Status: Y N U **Area Walk-By Checklist (AWC)**Location: Bldg. REACTOR Floor El. 87 Room, Area¹ NW Diagonal Elevated Platform**Instructions for Completing Checklist**

**This attachment contains Appendix H from the report entitled,
“Edwin I. Hatch, Unit 1 and Unit 2, Individual Plant Examination of
External Events – Seismic”**

UNIT 2 – SEISMIC WALKDOWN ENGINEER CERTIFICATIONS

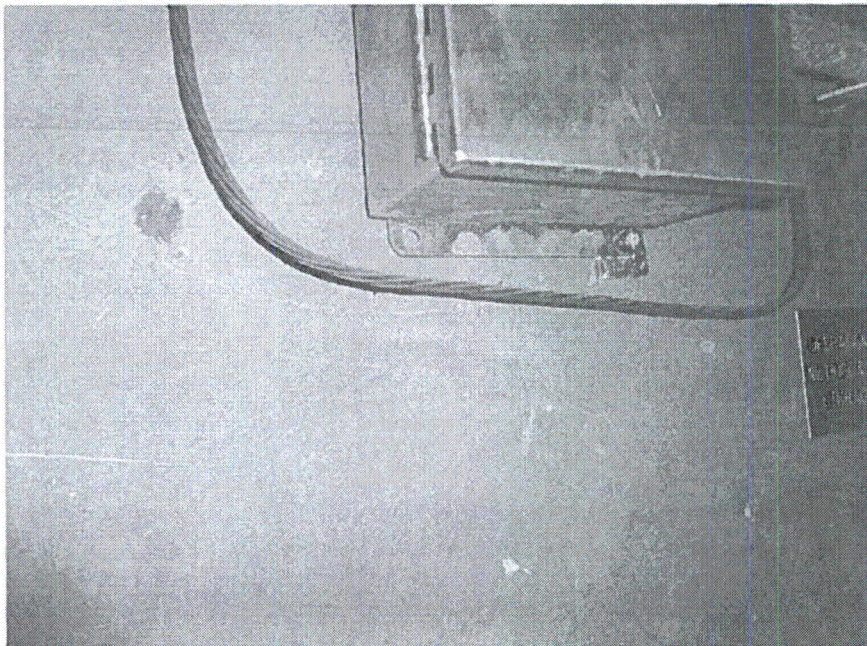
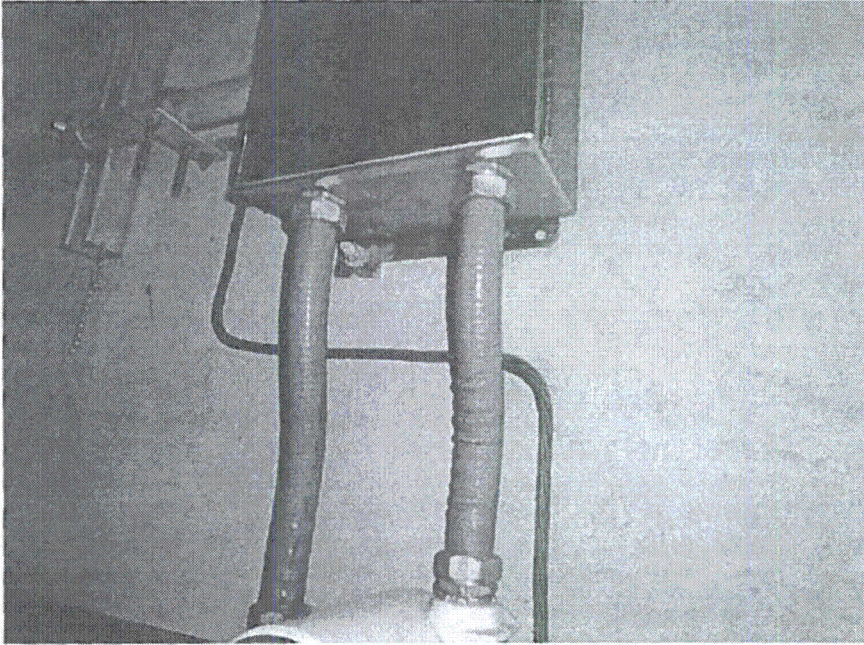
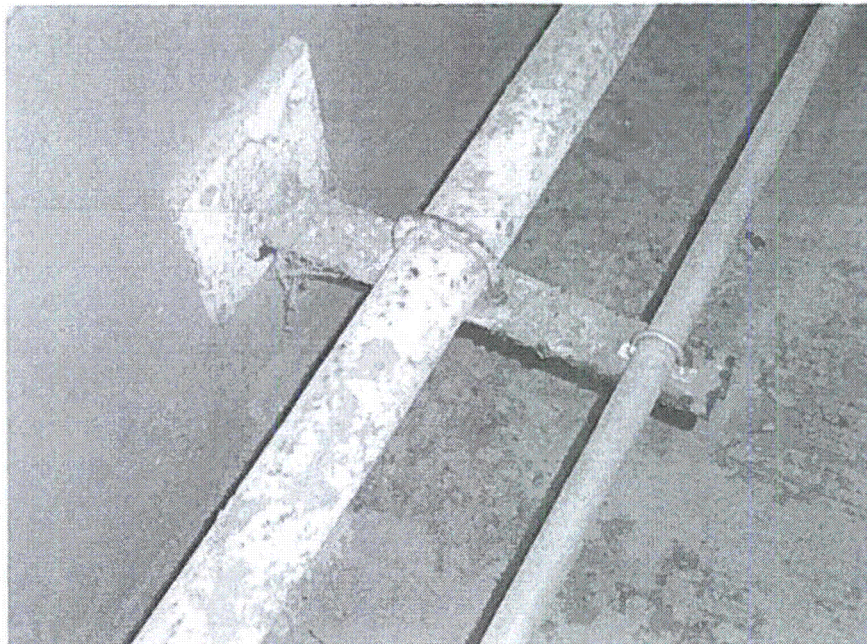
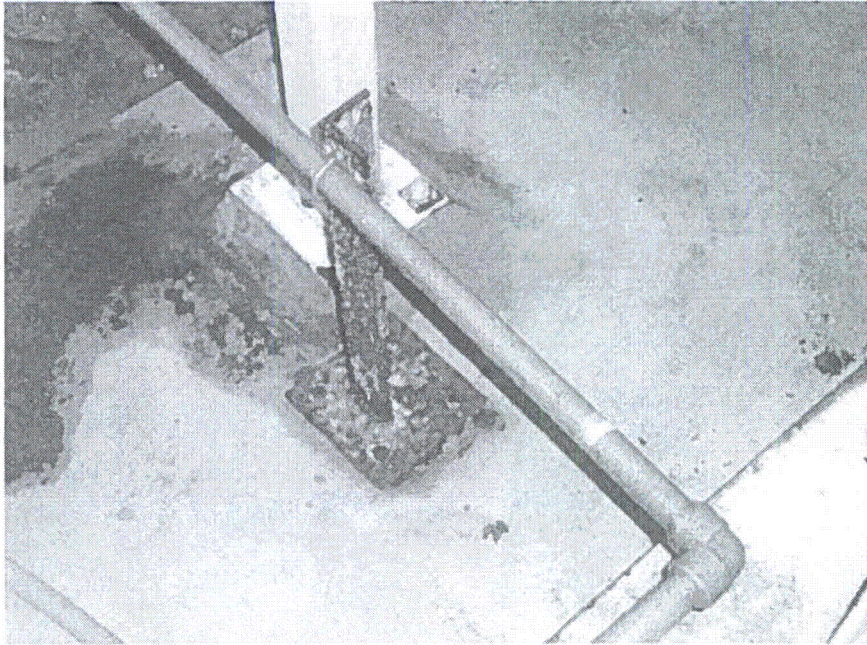
1. Does anchorage of equipment in the area appear to be free of potentially adverse seismic conditions (if visible without necessarily opening cabinets)? Y N U N/A
Oxygen Analyzer on the wall (2T48-R075) has 2 of the 4 bolts missing. Oxygen Analyzer on the wall (2T48-R076) has 1 of the 4 bolts missing. These items are rather light weight and SWEs judged these supports to be seismically adequate, however, CR525168 was initiated to replace these missing bolts.

2. Does anchorage of equipment in the area appear to be free of significant degraded conditions? Y N U N/A
Some surface corrosion on the nearby pipe supports was observed. These were judged to be seismically adequate by SWEs due to very light loads. However, CR525163 was initiated for this purpose to cover the corrosion issue in the area.

Figure 1 Conduit support in Torus Room Bay 10 with Missing Anchor

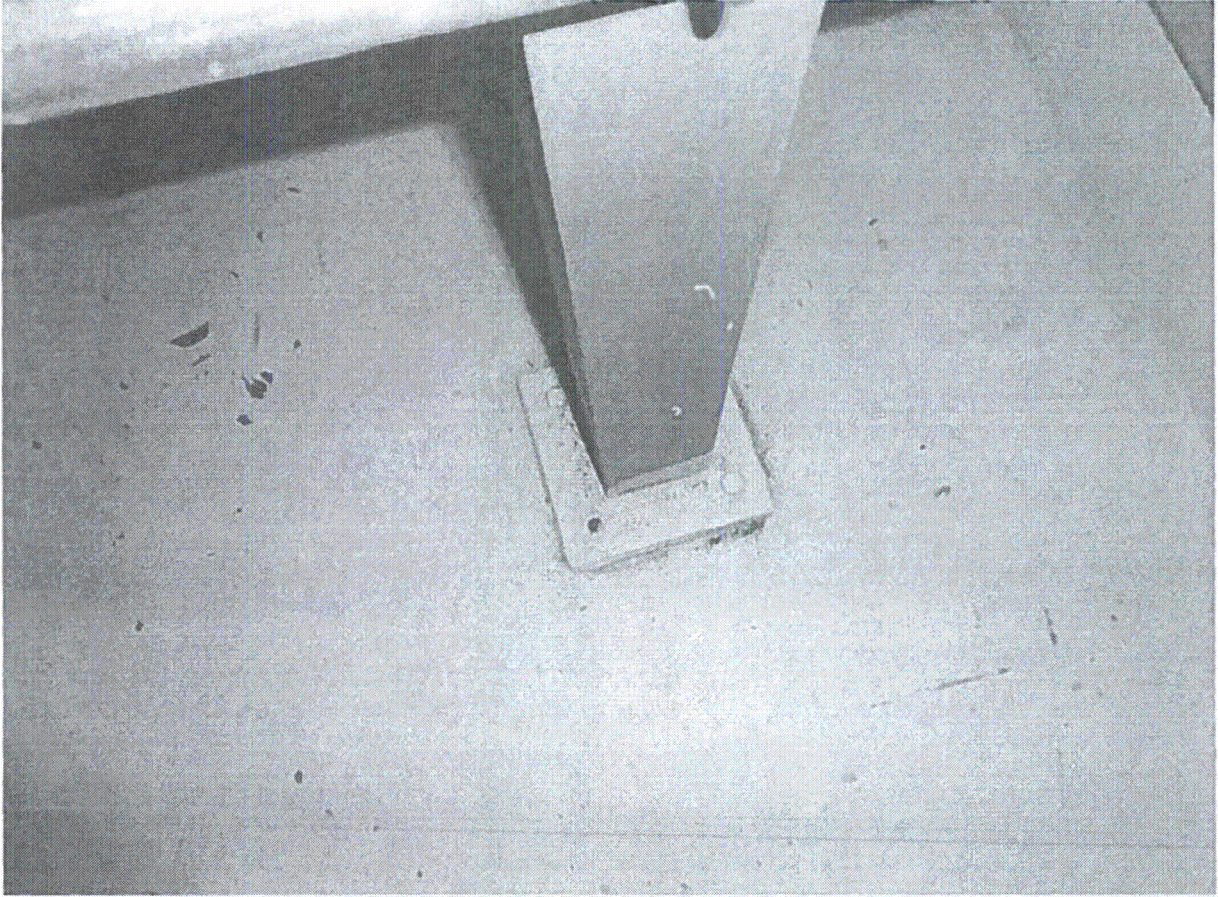
2. Does anchorage of equipment in the area appear to be free of significant degraded conditions? Y N U N/A
There is a four bolt base plate vertical support for a small bore air supply pipe running to 2E51-F003 that is missing one anchor bolt on the 87' elevation in Bay 10 of the Torus Room. This support is approximately 2 feet off the floor and it supports the end of the rigid pipe. The remaining portion of this system is flex hose to 2E51-F003 (See Figure 2). There is a similar support a short distance away that is intact. The pipe is well supported on the wall by its attachment to 2P52-A001. The support does not carry a large load and at this elevation would not see a significant seismic acceleration. Therefore, the SWE's have determined that the base-plate configuration is seismically acceptable. This bolt does not need to be installed.

Figure 2 Showing Air Line to 2E51-F003 and supports

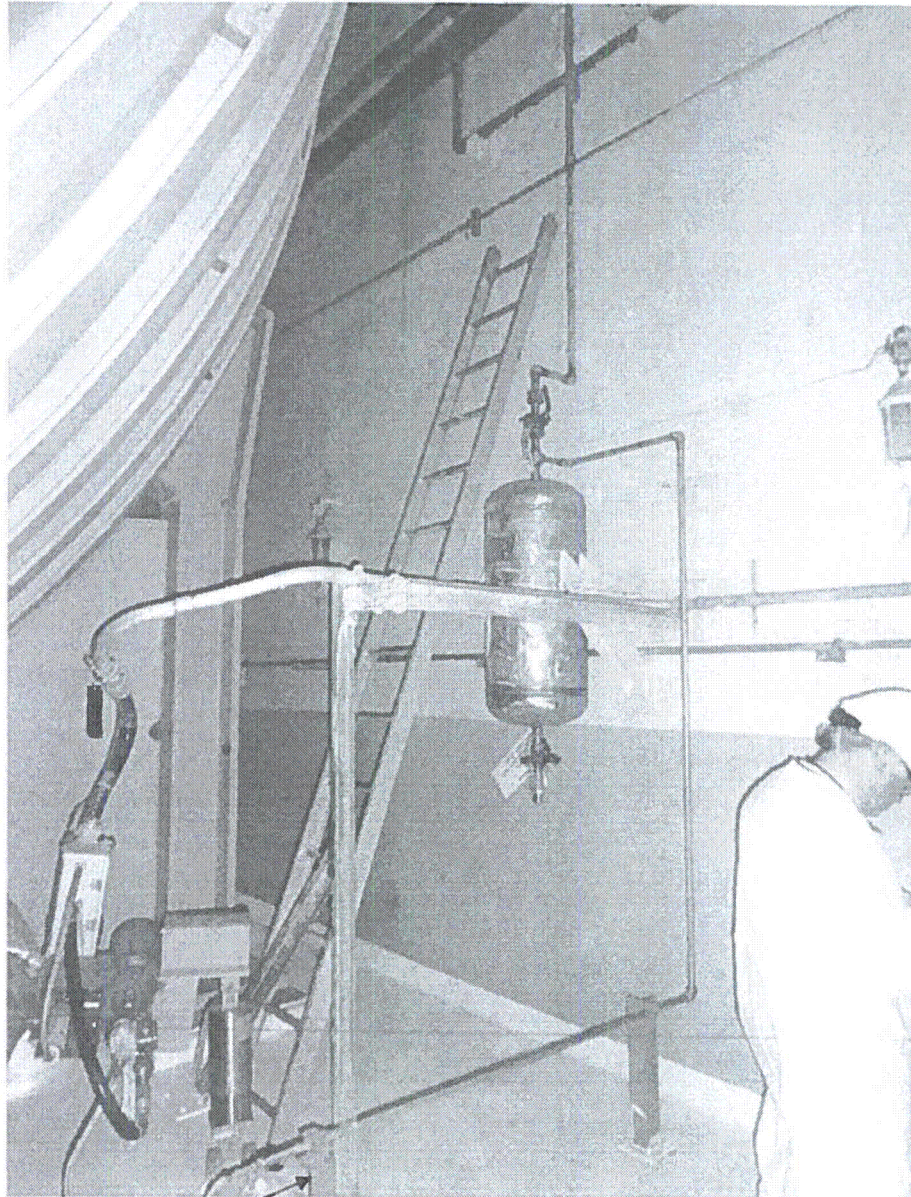
Support with missing anchor bolt
shown in Figure 1
